febi 101325,106911

Nissan Qashqai 2013 > (J11) model,
X-Trail 2014 > (T32)
Engine: K9K, R9M

Fuel Filter

Fig. 1 febi 101325

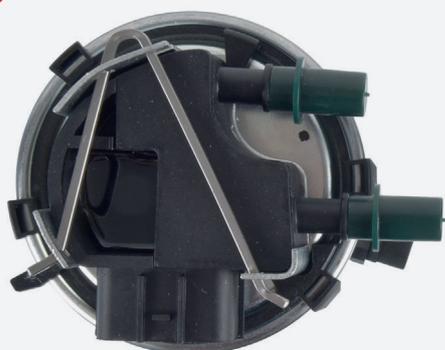
The water in fuel, lamp is illuminated on the vehicles dashboard display after the fuel filter has been replaced.

The incorrect filter has been fitted to the vehicle during servicing, due to a change in specification with the fuel heater/water sensor installed in the filter. This effects Qashqai models built from August 2014 and X-Trail models from December 2014.

The correct fuel filter required for the Qashqai models built before August 2014 and X-Trail models before December 2014 can be identified by a black fuel heater/water sensor inbuilt into the filter (Fig 1).

The correct fuel filter required for the Qashqai models built after August 2014 and X-Trail models built after December 2014 can be identified by a white fuel heater/water sensor inbuilt into the filter (Fig 2).
